Clearview - 8946 County Road 91 - 2021-076

NOTICE OF COMPLETE APPLICATION FOR
A DRAFT PLAN OF SUBDIVISION
8946 COUNTY ROAD 91
TOWNSHIP OF CLEARVIEW

**RE: Draft Plan of Subdivision - 1st Submission
Township File: 2021-076-SD
8946 County Road 91, Township of Clearview, County of Simcoe**

**RE: Proposed Draft Plan of Subdivision - Meliora Terra Limited
8946 County Road 91
Township of Clearview
Township File No. 2021-076
NVCA ID #42432**

ONTARIO PROVINCIAL STANDARD DRAWING	Nov 2018	Rev 1	
TURNING BASINS FOR TERMINATED RURAL ROADWAYS	-----	-----	OPSP ONTARIO PROVINCIAL MUNICIPAL STANDARDS

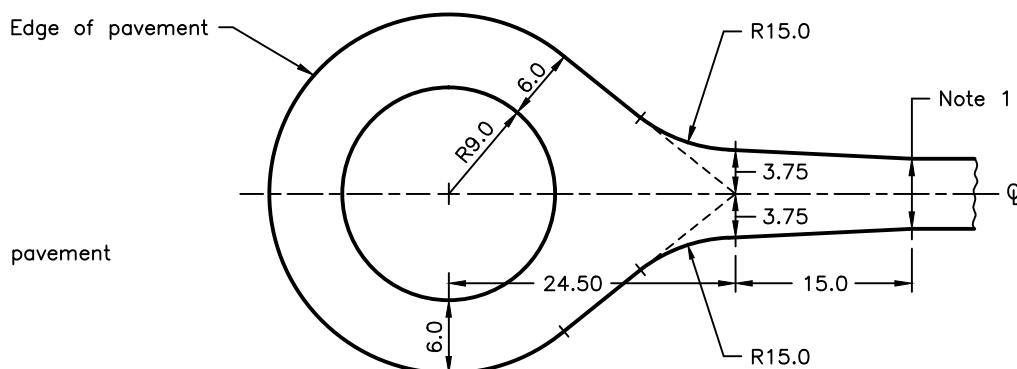
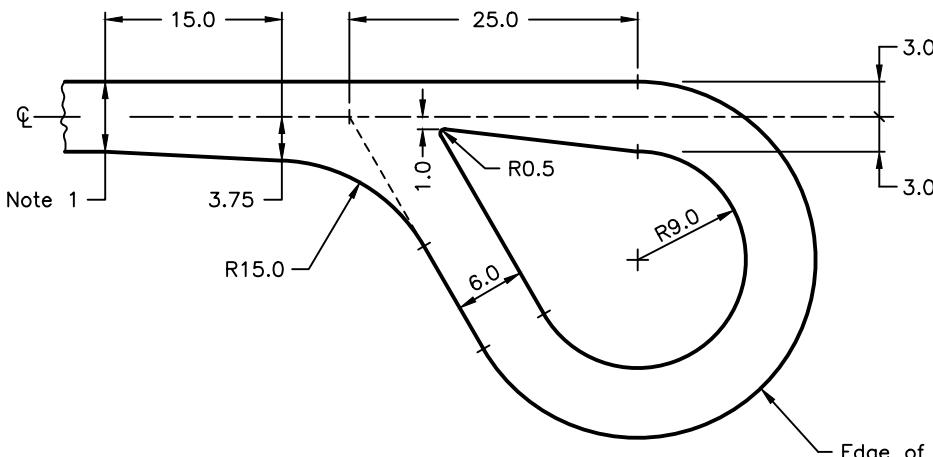
As this is a municipal road the County will provide waste collection service to the units fronting on the extended Sydenham Road East. However, the T-Turnaround at the terminus of the proposed extension of Sydenham Trail East has not been designed to meet the standards as identified in the engineering drawings provided. Specifically, the turning radii for the T-turnaround is identified as 8 m while the County's current minimum design requirement is 13 m.
